VSP - 148  
DATE: October 3, 2002 (S)

**SUBJECT:** Distribution of: **Lycoming Service Bulletin No. 554 and Lycoming Service Bulletin No. 554 Supplement No. 1**

DATE: September 30, 2002 Service Bulletin No. 554  
Engineering Aspects of this  
Service Bulletin are FAA Approved

SUBJECT: Crankshaft Gear Retaining Bolt Replacement

Figure 1.

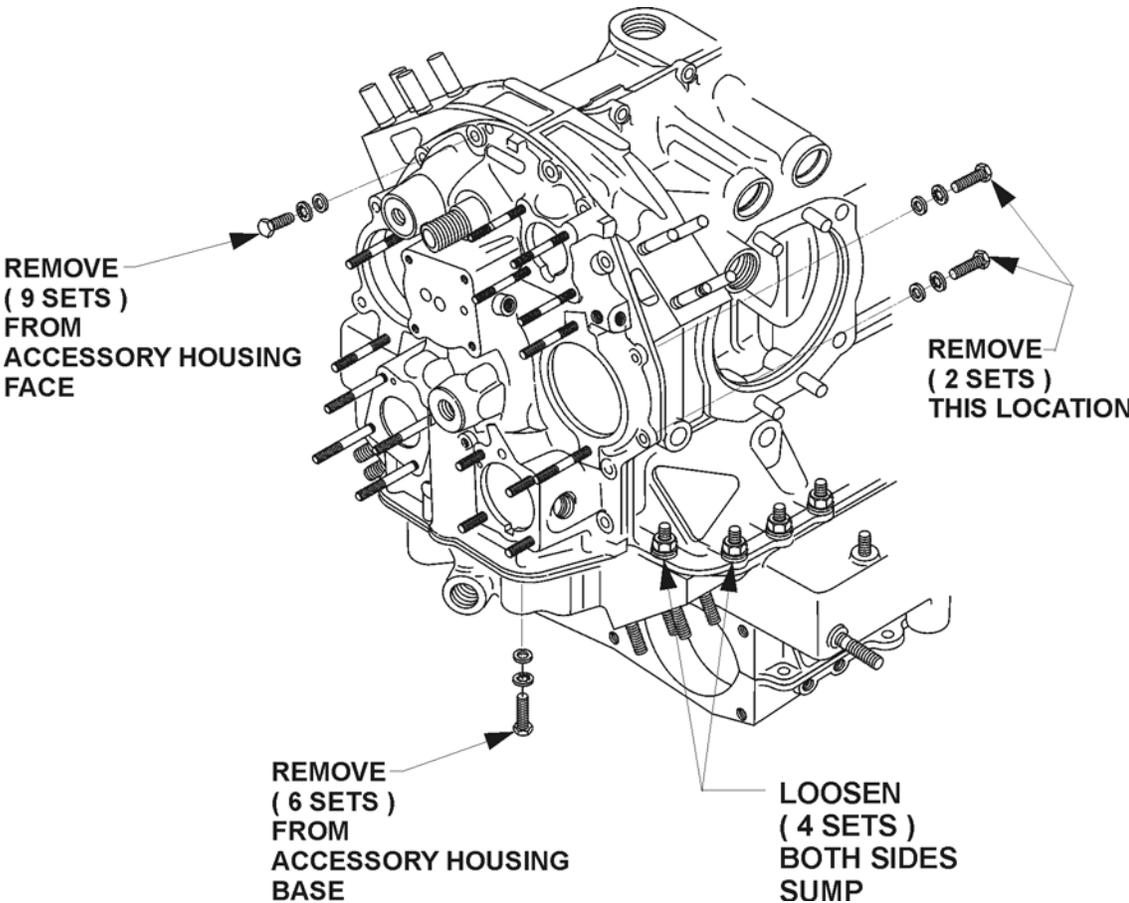
1. Bring No. 1 cylinder to top dead center compression stroke.
2. Remove all accessories on the accessory housing.
3. Remove all perimeter bolts and bottom bolts (thru the sump flange). (Refer to Figure 1.)
4. Loosen two nuts on each side of the sump. (Forward of the accessory housing attaching bolts.) (Refer to Figure 1.)
5. Carefully remove the accessory housing. This may require a small tap with a non-metallic mallet to get the accessory housing started off the two locating dowels. Be certain that the idler gears are not dropped, causing damage as accessory housing is removed.
6. After the accessory housing is removed, it is extremely important to ascertain no foreign objects fall into the oil sump.
